## STAFF RECOMMENDATION 4302 Elkins Avenue November 14, 2012

**Application:** New construction – accessory building and Setback reduction  
**District:** Park and Elkins Neighborhood Conservation Zoning Overlay  
**Council District:** 24  
**Map and Parcel Number:** 09116019400  
**Applicant:** Jan Watson  
**Project Lead:** Sean Alexander, sean.alexander@nashville.gov

1 SITE PLAN  
SCALE 1/32" = 1'-0"

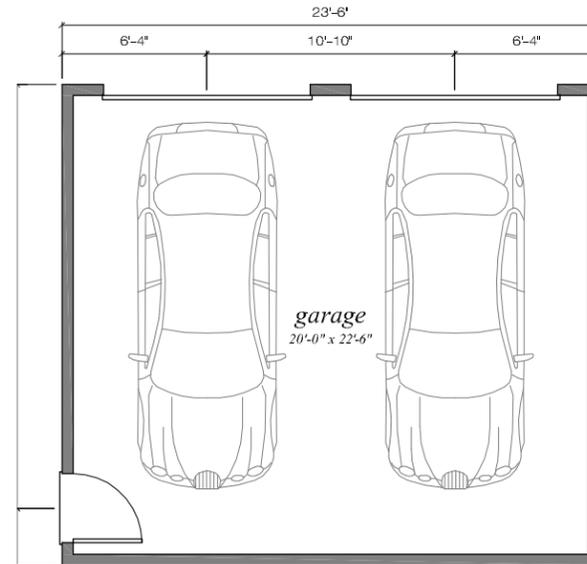
The building will be located three feet (3') from the right property line and five feet (5') from the rear. This location is consistent with the typical location of historic accessory buildings, but would require a reduction of the rear setback, which is currently ten feet (10'). Staff finds the location to be appropriate and to meet guideline II.B.1.2.

3 ELEVATION  
SCALE 1/8" = 1'-0"

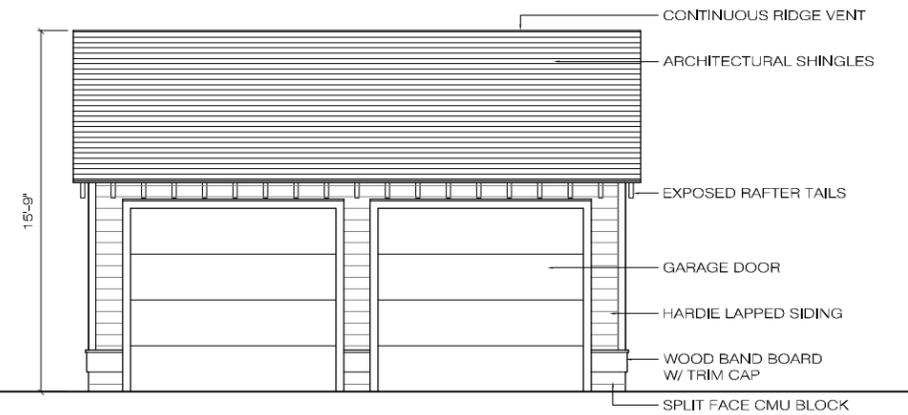
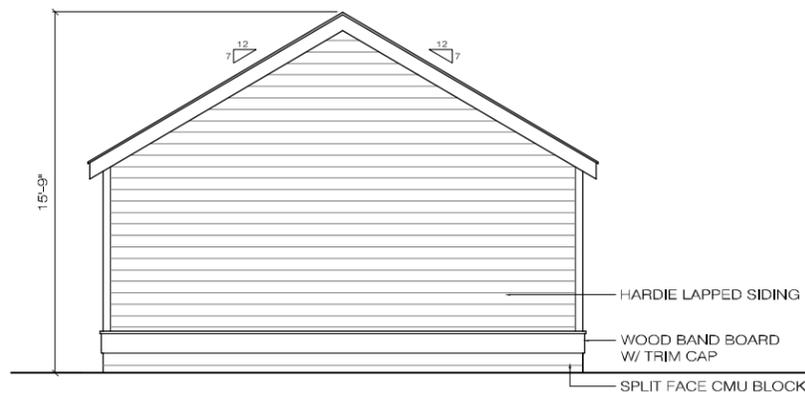
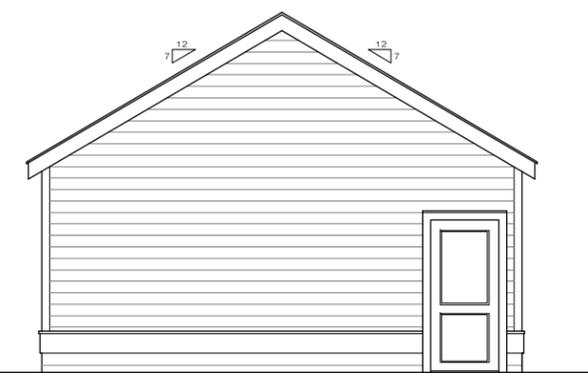
The materials will match those of the house: smooth-faced cement-fiber siding with a five inch (5") exposure, split-faced concrete block foundation, and a fiberglass asphalt shingle roof matching the color of the roof of the house. The pedestrian door facing the interior of the lot will be steel, and the exterior trim will be wood. The garage doors will face the rear alley. The materials and character of the new accessory building meet guideline II.B.1.1.

The building will be fifteen feet, nine inches (15'-9") tall with an eave height of nine feet (9'), with a twenty-one foot by twenty-three foot six (21' x 23'-6") footprint. The project meets section II.B.1 a and b.

The roof will be a side-oriented gable with a 7:12 pitch. This roof is compatible with that of the house and with surrounding historic structures, and meets guideline II.B.1.e.

The garage will have two overhead or roll-up type garage doors facing the alley, and a standard pedestrian door facing the interior of the lot. There will be no other windows, which is common for accessory structures. The application meets guideline II.B.1.g.
